Addendum No. 5

**RFP No. 23-29
FIRE TRAINING CENTER SITE CONSTRUCTION
SERVICES**

2 ASPHALT PAVING WITHIN RIGHT-OF-WAY
NOT TO SCALE

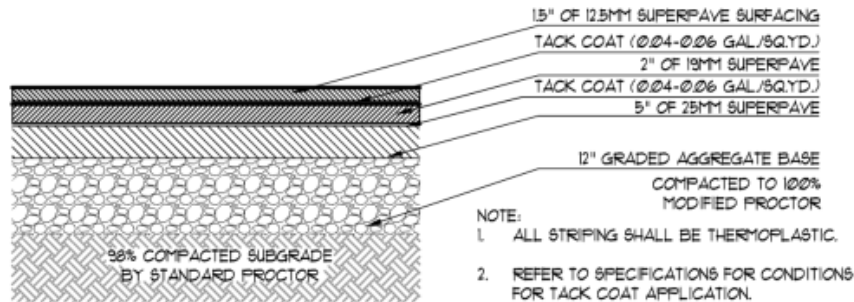
A. Question: Can you tell me if the entrance is asphalt paving or concrete apron on sheet C-2.00? Is it to be quoted as HD asphalt as it isn't shaded the same? If not, HD asphalt I need to know the paving specs for this section as there is no other asphalt paving details.

Answer: The entrance to the site is proposed to be paved with heavy duty asphalt. A different hatch is shown within the right of way since there are different requirements for paving within the right of way.
